**TRANSMITTAL OF RESPONSES TO THE U.S. ENVIRONMENTAL  
PROTECTION AGENCY AND OHIO ENVIRONMENTAL PROTECTION AGENCY  
COMMENTS ON THE RESTORATION AREA VERIFICATION SAMPLING  
PROGRAM PROJECT SPECIFIC PLAN AND THE REVISED PROJECT  
SPECIFIC PLAN**

**U.S. EPA TECHNICAL REVIEW COMMENTS  
ON THE RESTORATION AREA VERIFICATION  
SAMPLING PROGRAM PROJECT SPECIFIC PLAN**

**OHIO EPA TECHNICAL REVIEW COMMENTS  
ON THE RESTORATION AREA VERIFICATION  
SAMPLING PROGRAM PROJECT SPECIFIC PLAN**

**PROCESS FOR DEVELOPMENT OF GROUNDWATER FRLs.**

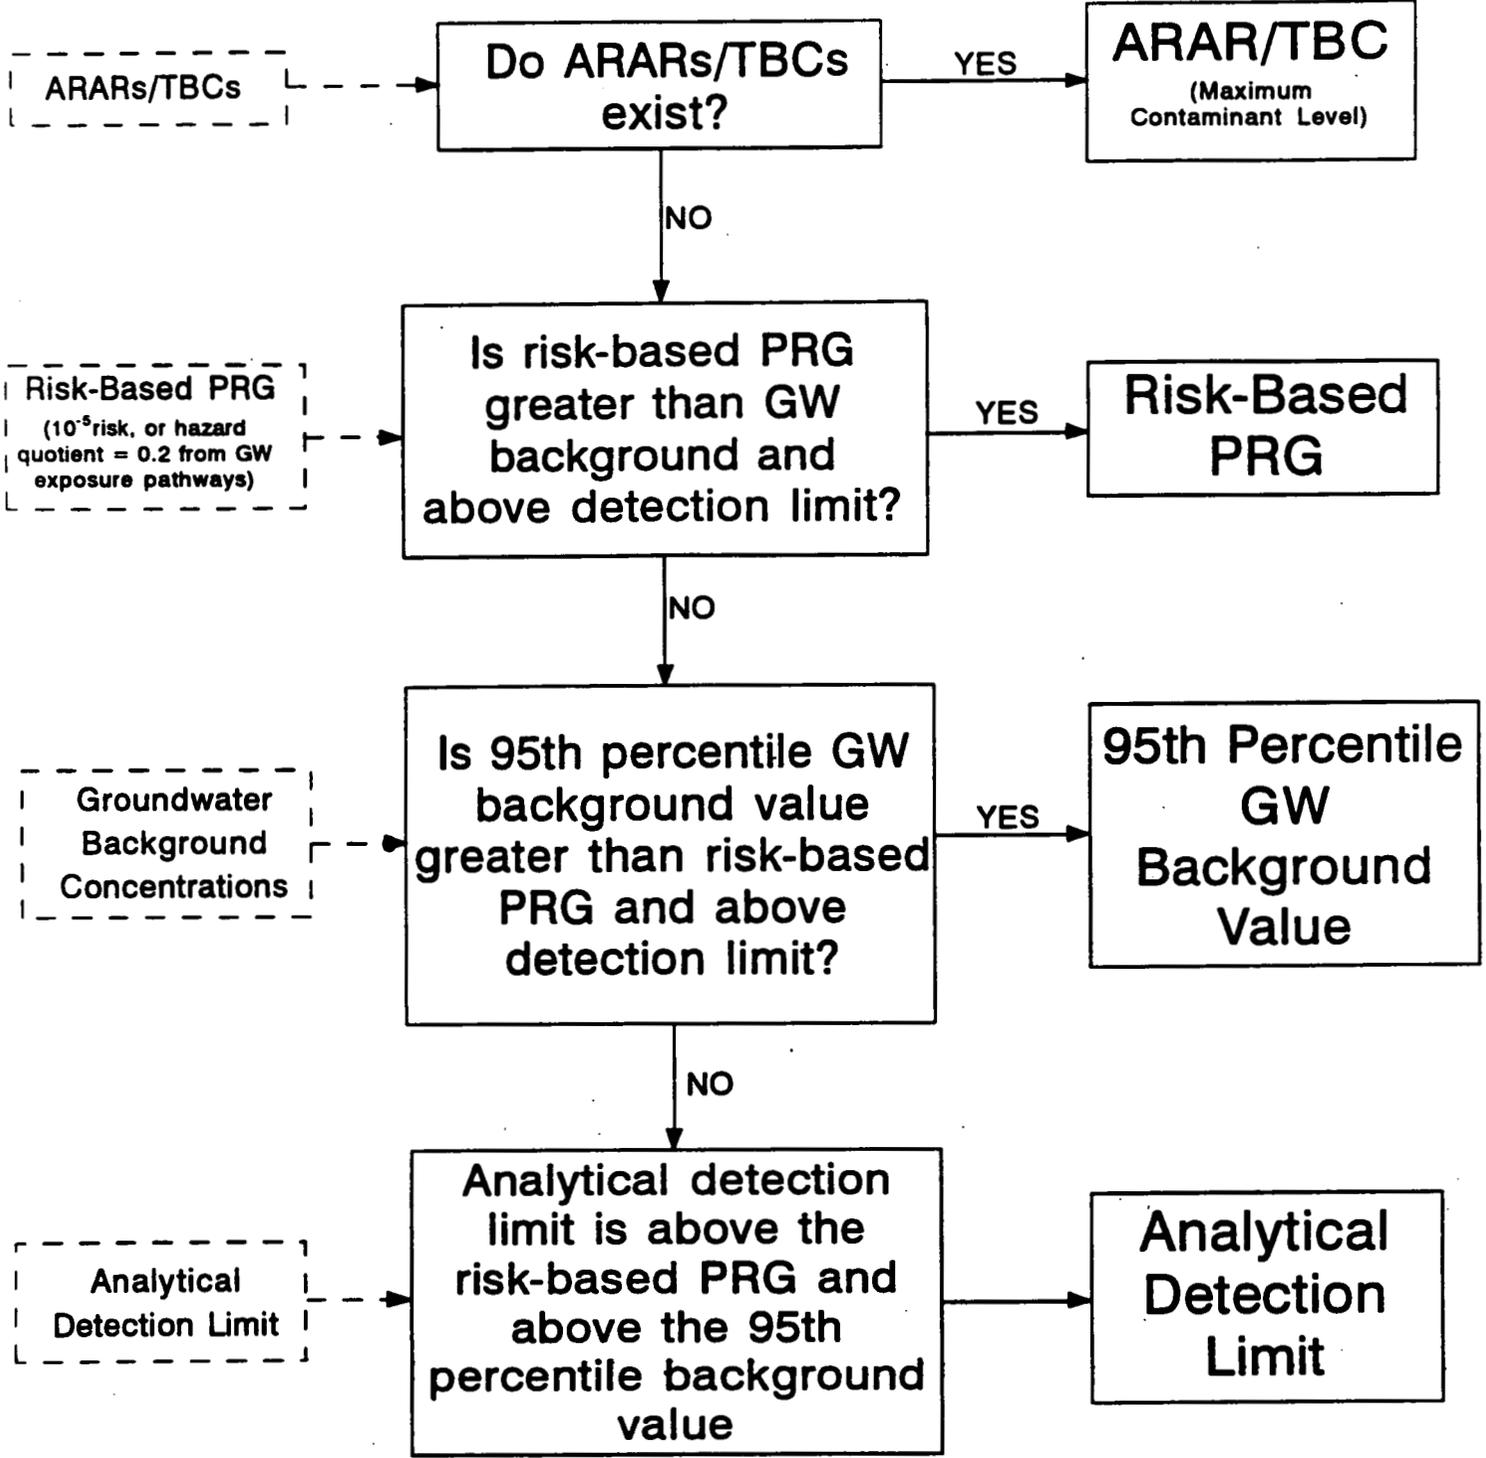
Response: Agree that this issue warrants further discussion and that discussion took place at a meeting on December 19, 1996 with U.S. EPA, OEPA, DOE and FDF participating. In that meeting the development process for groundwater FRLs was revisited and discussed. This process is detailed in the Operable Unit 5 Feasibility Study. As discussed in the December 19 meeting the Operable Unit 5 Feasibility Study (Section 2, page 2-54) outlined two Cases for potential groundwater FRLs. These two Cases are: Case 1 which "considered a target risk level of  $10^{-6}$  ILCR and an HI of 0.2 to a resident farmer," and Case 2 which "employed the MCLs, proposed MCLs and nonzero MCLGs as target cleanup values. For those COCs with no MCLs, proposed MCLs, or nonzero MCLGs, Case 2 considered a target risk level of  $10^{-5}$  and an HI of 0.2 to a resident farmer."

As discussed at the December 19 meeting, Case 2 was ultimately selected as part of the preferred alternative in the approved Operable Unit 5 Proposed Plan and was subsequently utilized to establish the groundwater FRLs found in the final Operable Unit 5 ROD. The attached figure (Process For Development of Groundwater FRLs) was used in the 12-19 meeting to illustrate the Case 2 FRL development process. In the discussion of this process for the development of the fluoride FRL it was acknowledged that the MCL for fluoride (4 mg/L) was inadvertently overlooked, and according to the approved Case 2 development process the MCL should have been

selected as the FRL (the current FRL was inadvertently established based on the 95th percentile background concentration of fluoride, which is 0.89 mg/L).

Action: Revise the PSP to provide a more detailed explanation of why the current FRLs for fluoride and lead are inappropriate and provide additional justification (as outlined in the response to this comment) for the selection of new FRL values for these 2 parameters. The text in the PSP, Appendix A, page A-1 will be revised by incorporating the following text:

Case 2 was ultimately selected as part of the preferred alternative in the approved Operable Unit 5 Proposed Plan and was subsequently utilized to establish the groundwater FRLs found in the final Operable Unit 5 ROD. Figure A.1-2 (Process For Development of Groundwater FRLs) illustrates the Case 2 FRL development process. In the OU5 FS process for the development of the fluoride FRL, the MCL for fluoride (4 mg/L) was inadvertently overlooked, and according to the approved Case 2

development process the MCL should have been selected as the FRL; (the current FRL was inadvertently established based on the 95th percentile background concentration of fluoride, which is 0.89 mg/L) therefore DOE recommends the MCL for fluoride be adopted as the FRL.
